UNITED STATES PATENT AND TRADEMARK OFFICE

APPLICATION NO.	FILING DATE	FIRST NAMED INVENTOR	ATTORNEY DOCKET NO.	CONFIRMATION NO.
09/939,516	08/24/2001	John B. Harvey	26346-1	2442

Office Action Summary	Application No.	Applicant(s)
	09/939,516	HARVEY, JOHN B.
	Examiner Michael P. Ferguson	Art Unit 3679

DETAILED ACTION

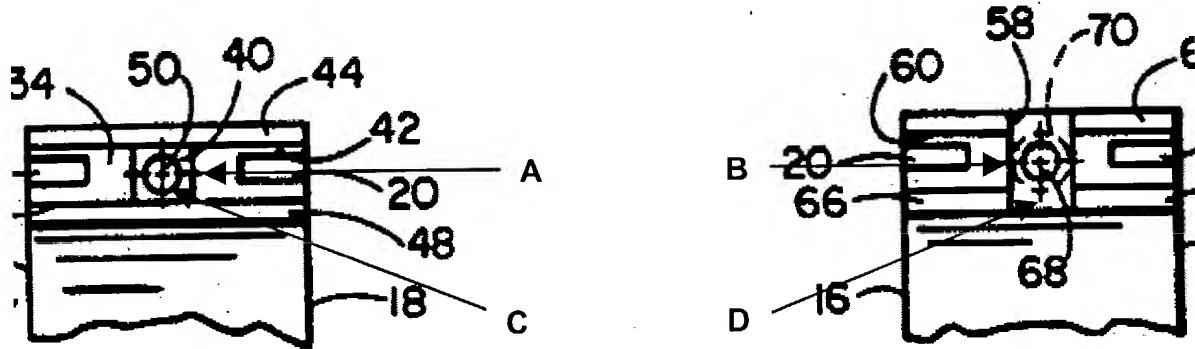
wherein the land has a first pair **A** (Figures 5 and 6 reprinted below with annotations) of planar alignment surfaces;

wherein the recess has a second pair **B** of planar alignment surfaces complimentary to the first pair of planar alignment surfaces wherein contact of the first pair of planar alignment surfaces with the second pair of planar alignment surfaces when the land is received in the recess provides axial alignment of the first semi-circular member with the second semi-circular member;

wherein the land has a third pair **C** of planar alignment surfaces; and
wherein the recess has a fourth pair **D** of planar alignment surfaces complimentary to the third pair of planar alignment surfaces wherein contact of the third pair of planar alignment surfaces with the fourth pair of planar alignment surfaces when the land is received in the recess provides radial alignment of the first semi-circular member with the second semi-circular member (Figures 1-6).

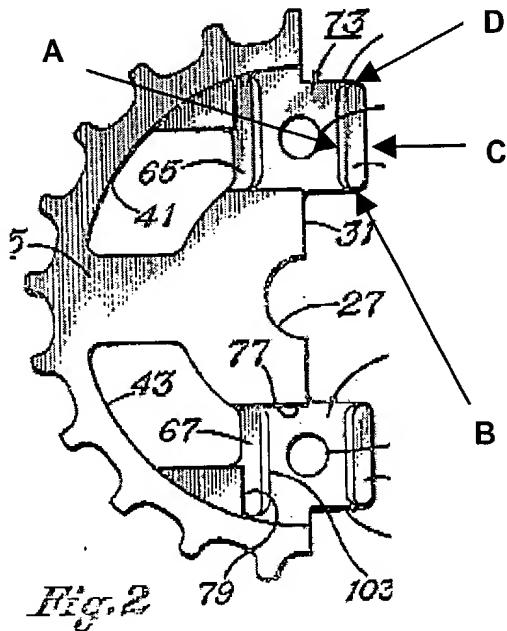
a first rectangular land **61,63** having a plurality of sidewall surfaces **A,B,C,D** (Figure 2 reprinted below with annotations) projecting from one of the first or second mating surfaces of the first member wherein the corners formed between adjacent sidewall surfaces of the first rectangular land are radiused;

a first rectangular recess **65,67** having a plurality of sidewall surfaces projecting into one of the first or second mating surfaces of the second member;

wherein the first rectangular recess is interengageable with the first rectangular land to provide axial and radial alignment of the first member with the second member; the radiused corners of the land providing for easier alignment of and insertion of the land into the recess (Figures 1-4).
